Planning

ASSESSMENT REPORT

Section 75W Modification Moolarben Coal Pty Ltd

Figure 3: Moolarben Coal Project – Amended Stage 1 Infrastructure Layout

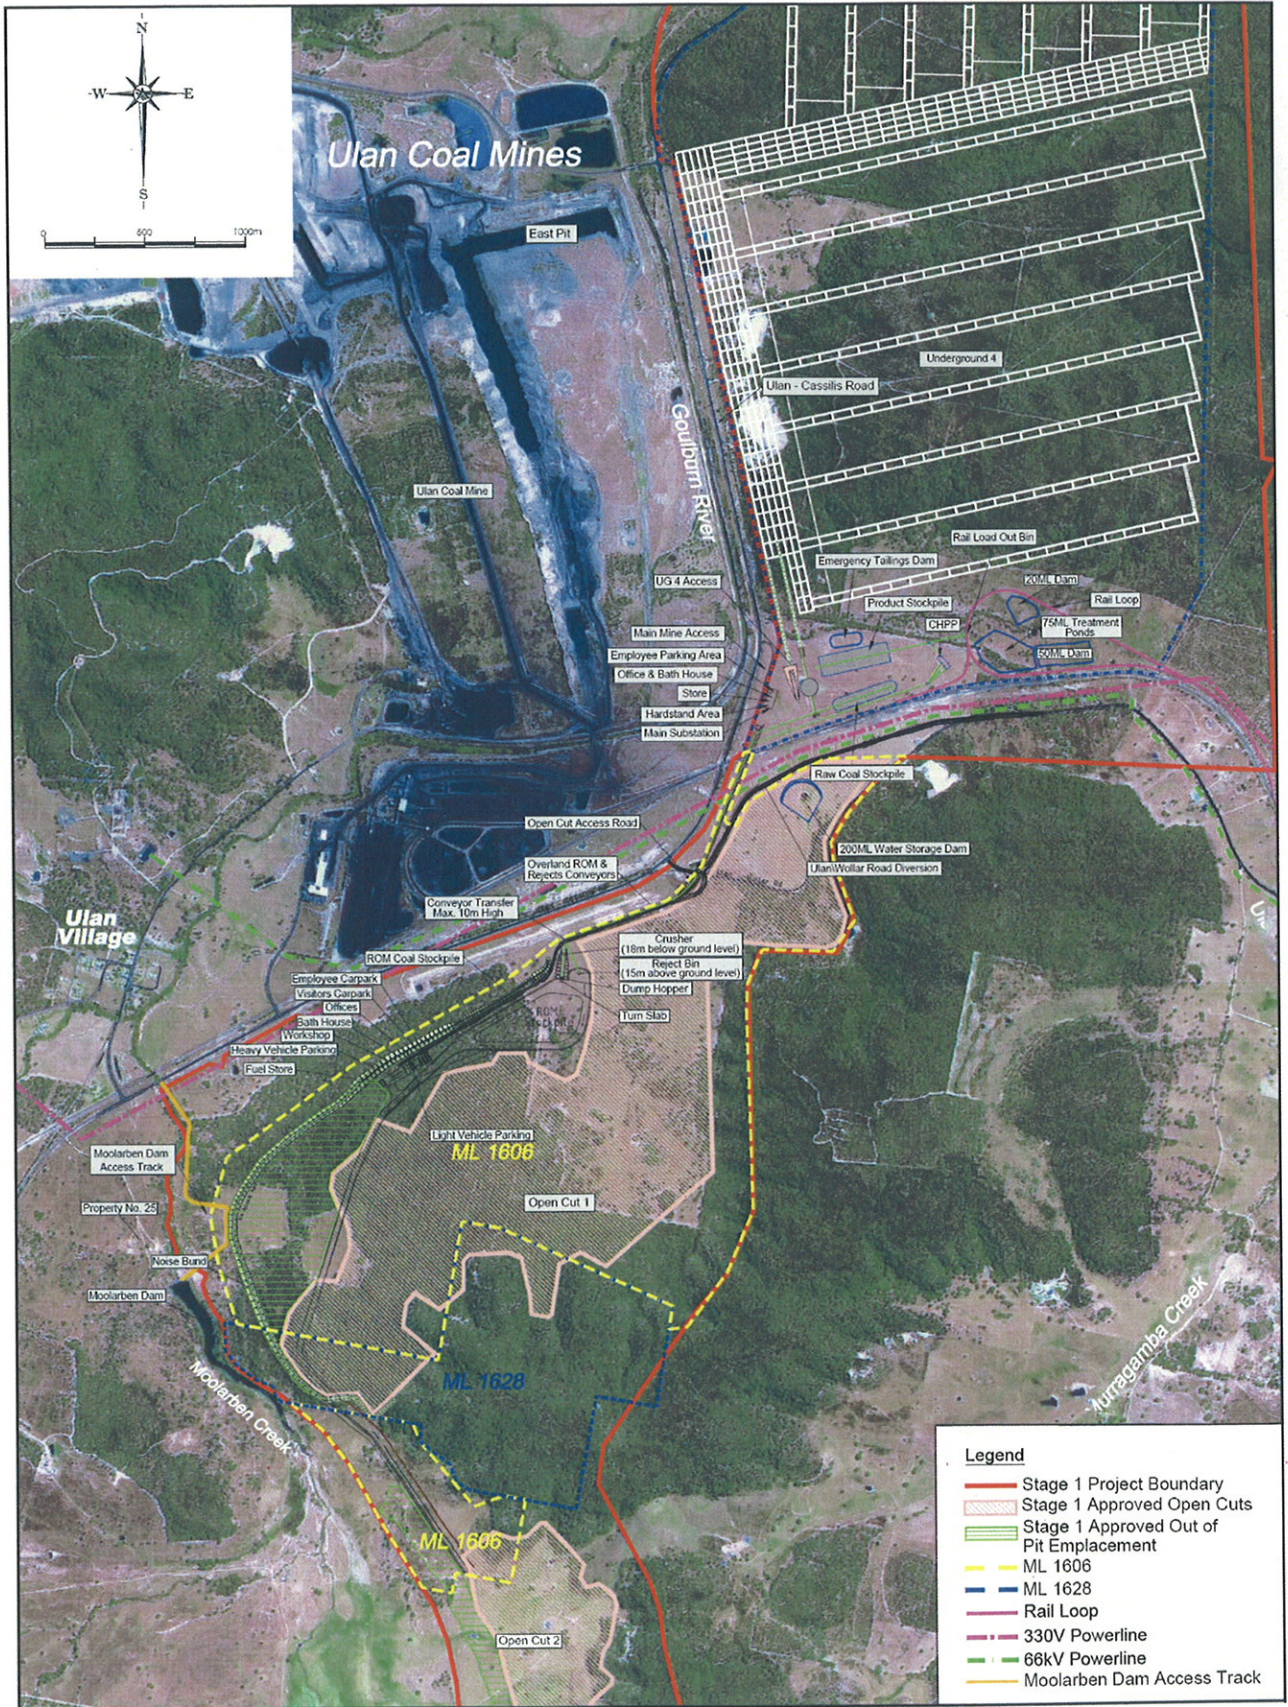
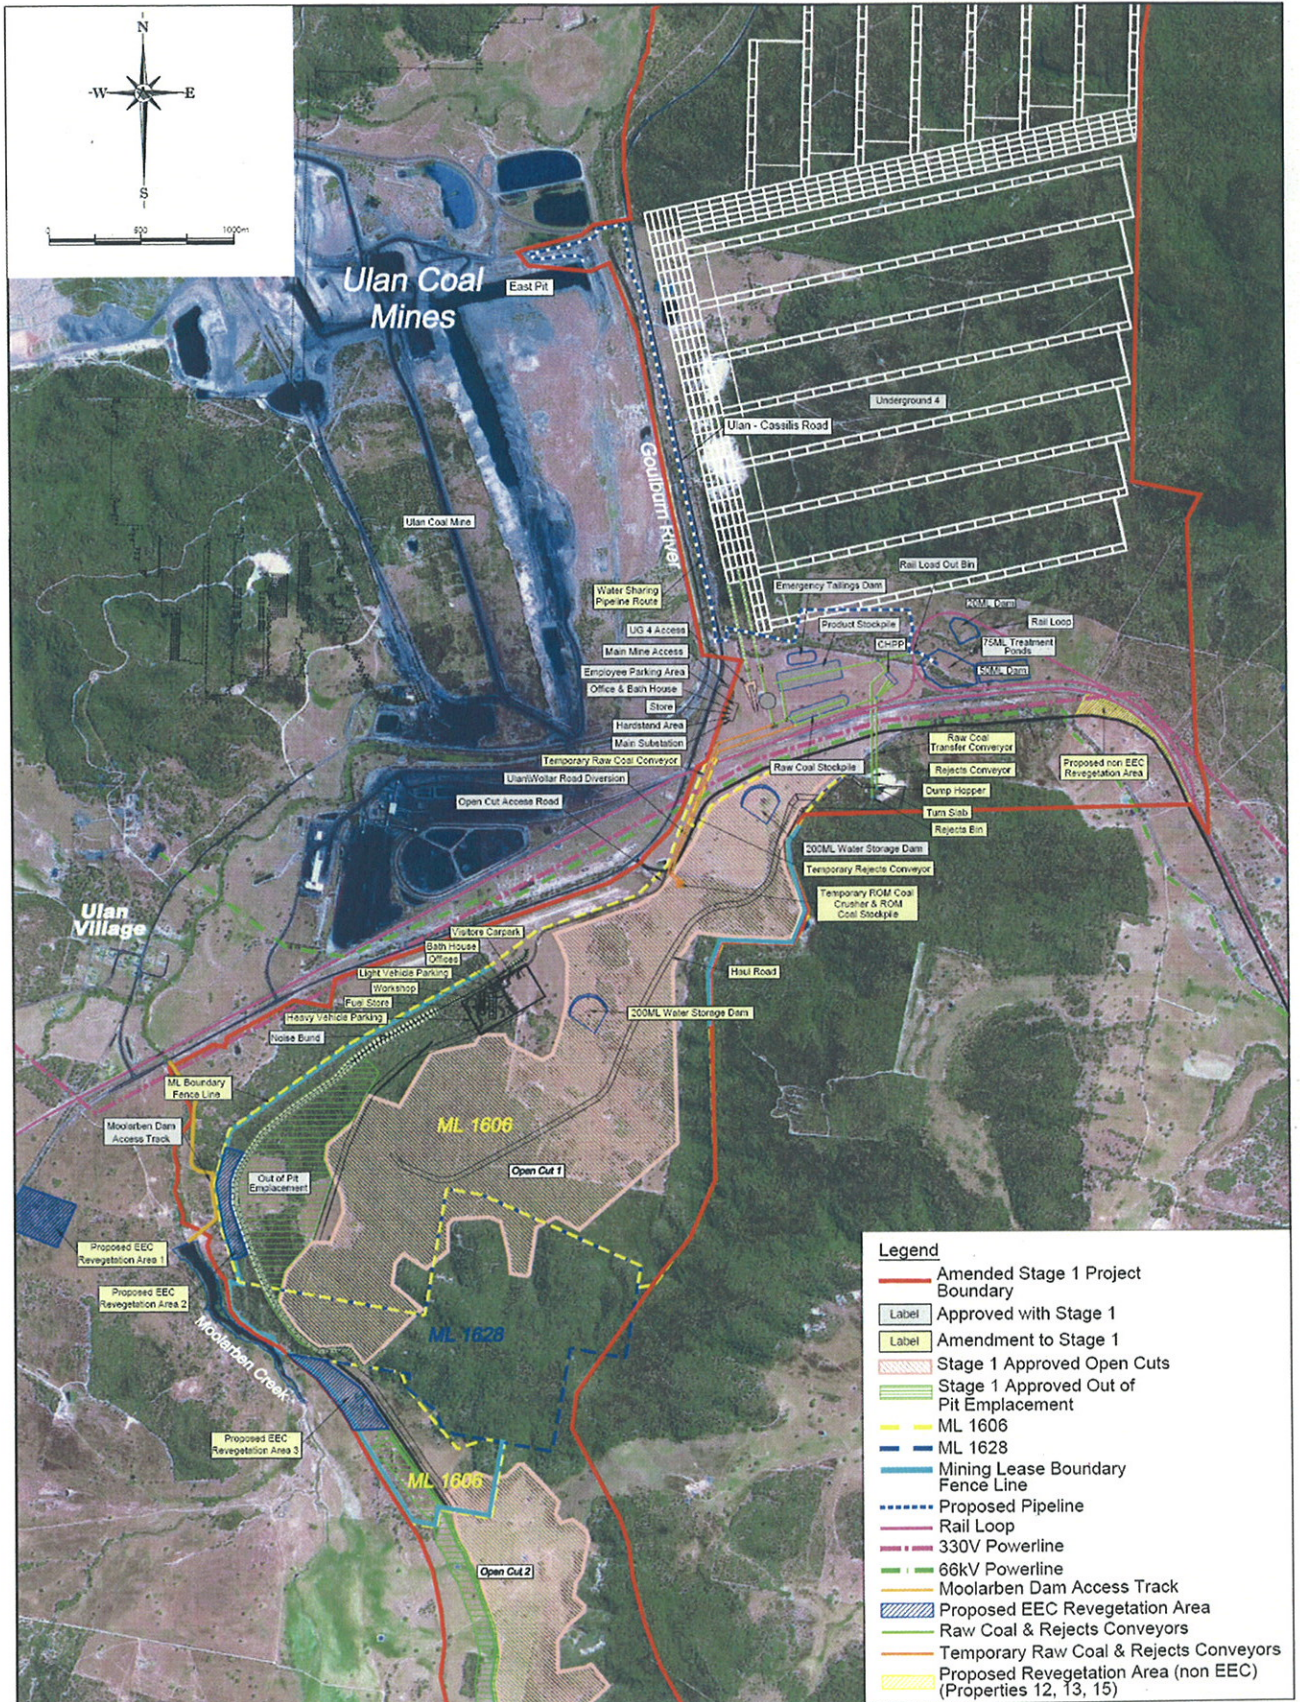
The approved and proposed surface infrastructure layouts are shown on Figures 2 and 3 respectively. Proposed infrastructure layout changes involve:

- **Relocation of ROM Coal Facilities** – Relocation of the open cut ROM coal facilities (ie. dump hopper, primary crusher, rejects bin and associated coal conveying facilities) from the approved location on the western edge of Open Cut 1 (OC1) to the south of the main infrastructure area. This will require the use of an additional 2 kilometres (km) of haul roads. The relocation would allow the integration of the Stage 1 and Stage 2 infrastructure and would provide Moolarben with improved coal handling efficiencies and reduced capital expenditure and operating costs.

- **Relocation of Open Cut 1 Support Infrastructure** – Relocation of OC1 support infrastructure (ie. office, workshop and associated facilities) from the approved location on the western edge of OC1 to an area approximately 500m to the northeast. Access will remain via the approved access road, off the Ulan-Wollar Road.
- **Ulan-Moolarben Water Sharing Pipeline** – Construction and operation of a water sharing pipeline from Ulan Coal Mine's (Ulan's) east pit to Moolarben's Stage 1 infrastructure area. Ulan has a net water surplus of approximately 2,720 mega litres per year (ML/year) and Moolarben is predicted to have a water deficit ranging from 310-960ML/year in years 6 to 16 (Stage 1 and 2

Moolarben seeks to modify the approved Stage 1 project boundary to accommodate the proposed relocated open cut ROM coal facilities and the water sharing pipeline (Figure 3). It also proposes to adjust the Stage 1 boundary to the east of Underground 4 (UG4) to align it with an adjustment that was made to the adjoining Goulbourn River National Park boundary (Figure 3).

Moolarben has acknowledged that it did not have approval to undertake the 3.9 ha of clearing along the boundary fence and has subsequently offered a biodiversity offset to compensate for the loss of this vegetation, as well as the other 6.39 ha of clearing required for the construction of the ROM coal facilities. The location of these offsets is shown in Figure 3 and includes:
